Access Compliance Report

Public Rights-of-Way

| Intersection ID: 28272 | Main Street: PEMSWOOD_ST | Cross Street: PURCHASE_ST | Location: S |
| ADA ID: 0816EB5D7902 | Ramp Type: PerpDiag | Initial Pass/Fail: Fail | Overall Compliance: No |

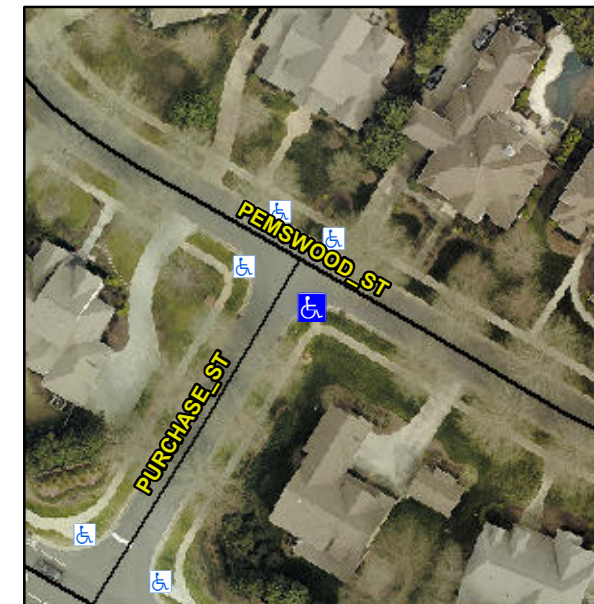
Not Found, R304.2.2, R304.5.3

| Compliance | Description | Data | Compliance | Description | Data |
|------------|-----------------------|-------|------------|-----------------------------|-------|
| N/A | Ramp Length (in) | 95.0 | No | Ramp Slope (%) | 8.8 |
| Yes | Ramp Width (in) | 53.0 | No | Ramp XSlope (%) | 5.3 |

Remove & Replace Curb Ramp With Two New Directional Ramps or Equivalent.
